STAFF REPORT

Planning Commission Meeting: May 1, 2025	Prepared By: Natalie Davis McKeown
Topic: “City Park Remaster” Site Plan and Variance PID: 23-119-23-34-0001 and 23-119-23-43-0007 City File No. 25-015	Action Required: Recommendation

This is a City-initiated request for the approval of a site plan and two variances to complete park improvements at City Park, including a new park building, located at 20400 and 20200 County Road 50.

BUILDING PROGRAM / FLOOR PLAN

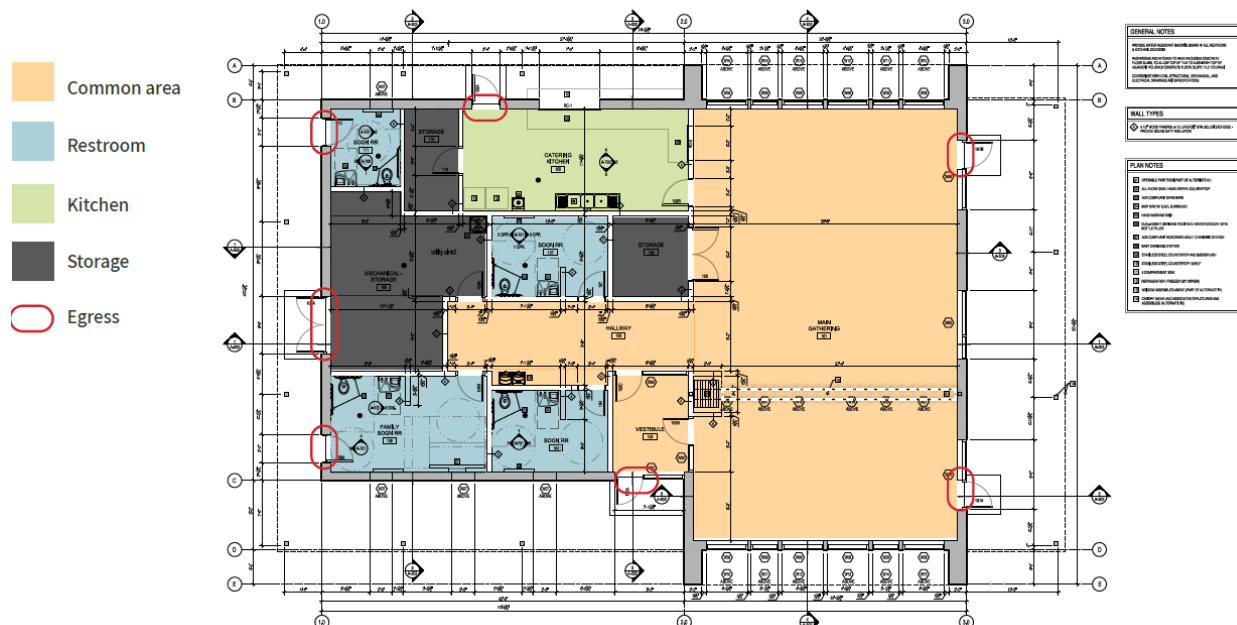
Three storage areas are shown on the plans for building mechanical, table and chair storage, and within the catering kitchen. The building is anticipated to support City-run programs and events, with the kitchen storage location utilized to store frequently used

items. A catering kitchen is shown including a three-compartment sink, refrigerator/freezer, handwashing sink, and preparation countertops. It will have direct access to the larger gathering space, an exterior door, and a serving window for coordinated use with the future patio and shelter.

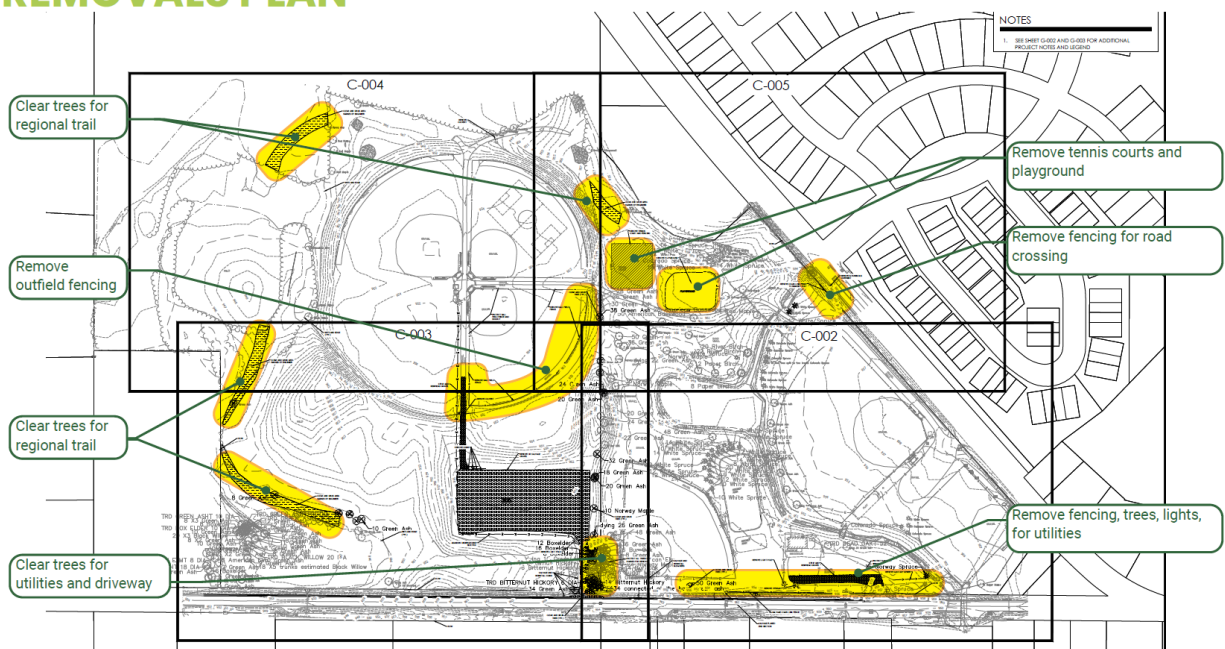
The site plan shows 59 paved parking stalls where 31.25 spaces are required to serve the new building. There is gravel shown around the paved parking for overflow parking for roughly another 156 spaces. This more than exceeds the minimum parking required for the overall park without factoring in the additional parking areas provided in the other 3 gravel lots on the east parcel. The City is also receiving bids to fully pave the parking area. It may be that the parking lot is paved initially or in phases as funding allows, similar to the Three Rivers Regional Trail. The parking lot must be paved no later than Phase 2 of improvements to City Park. If possible, staff recommends paving the entire parking lot at the same time. Concerns with maintenance and the ability to keep clear

fire lanes within the gravel area were noted as concerns with Public Works and Public Safety.

Buffer Yard Waiver

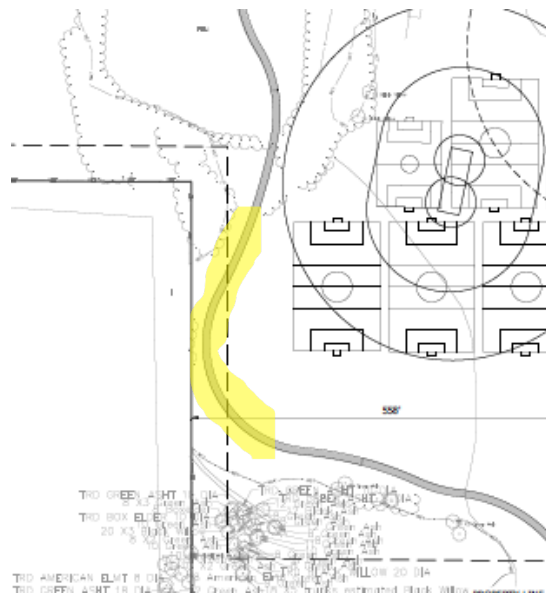
Section 1060.070, Subd. 2(J) requires a class “D” buffer yard between the western boundary of City Park and the adjacent UR neighborhood. However, a conflict is created within a portion of this buffer yard area with the proposed alignment of the Diamond Lake Regional Trail corridor. The trail was designed to meet all Three Rivers requirements and provide a meandering experience of the park overlooking the fields, traversing a boardwalk, and connecting to the playground and other amenities. The proposed trail location is reasonable as it provides a path between the stormwater ponding, and area that would otherwise go unused. Additionally, the proposed design and location will provide interest while maximizing the park area. Additionally, it is odd to require a buffer yard within a conservation easement within a public park.

The condition upon which the variance is sought is unique in that all other City parkland is still guided and zoned residential. This is the only City park land currently guided Parks and Open Space and zoned P-I, The P-I designation is what is driving the buffer requirement along the west boundary, whereas parks under the same zoning district as the surrounding area would not need to provide a buffer. The condition upon which the variance is sought is based on the necessity of designing the site to provide the most public benefit rather than on a condition created by the landowner. Further, City Park is already held within the public interest, which makes it a unique situation as there is not a need to put an easement in the name of the City for land already owned by the City.

Granting the variance will not alter the essential character of the surrounding area. The lot to the west is heavily forested, and there is already a slight gap in the tree line/wetlands today where the trail is proposed. A small change in this gap to allow for the Diamond Lake Regional Trail will not alter the essential character of the surrounding area.

The variance is overall consistent with the intent of the ordinance. The intent of the ordinance was to provide a transition to minimize the impacts of differing land uses, but open space and parks are generally considered complimentary to residential uses. This is evidenced by the fact that parks are a by-right permitted use in residential districts, such as RSF-1. Further, trees that do not need to be removed will remain, which means a heavy tree line and the existing wetlands will provide a buffer yard along most of the western property line, and some areas of the existing tree line exceed the required buffer yard width. The variance will grant flexibility in this one location where the trail corridor is planned within what would otherwise be the buffer yard area. Additionally, the fact the buffer yard area is on public property is overall consistent with the requirement for the buffer yard to be within a conservation easement in favor of the City.
